GARAVENTA HILLS PROJECT

Final Environmental Impact Report

SCH No. 2011112045

June 2014

Figure 22.1: Revised Project Site and Grading Plan

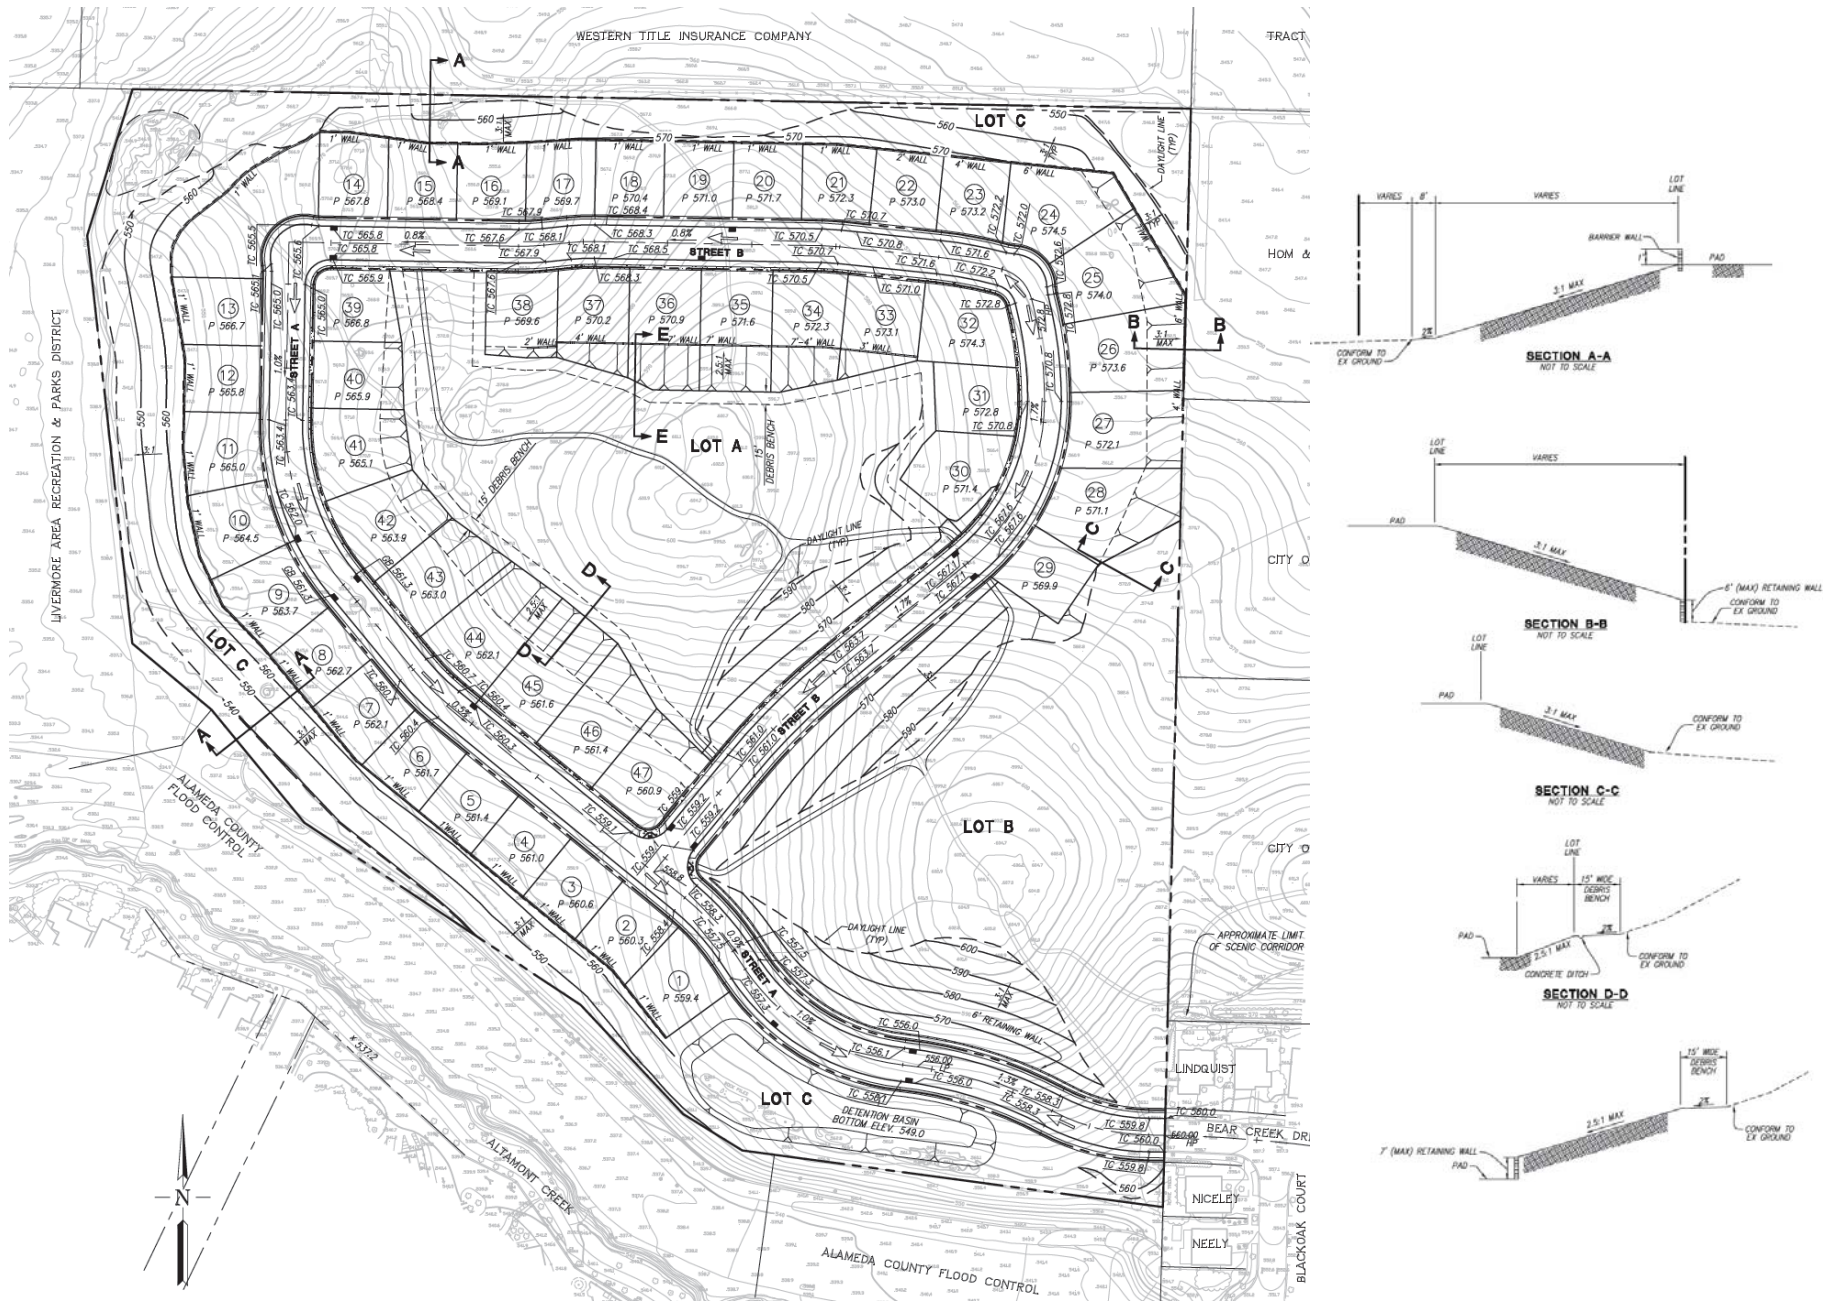
The knoll closest to and visible from Altamont Creek Park will remain largely undeveloped (identified as Lot B on Figure 3.2 of the Draft EIR and Figure 22.1 of the Final EIR). As shown on page 4-9 of the Draft EIR, while some homes will be visible from Altamont Creek Park, the knolls will also continue to be visible.

This is not a comment on the environmental analysis. Livermore's General Plan and Development Code do not include provisions for a Maximum Developable Area for residential uses. The applicant modified the initial site plan to reduce grading and retain the knolls. This resulted in some portions of rear yards requiring retaining walls and 2.5:1 slopes. As shown on the grading plan and related section plans, the steeper slopes are a portion of some of the lots and not intended as the only yard space (Draft EIR page 3-1 and the Revised Project in Figure 22.1).
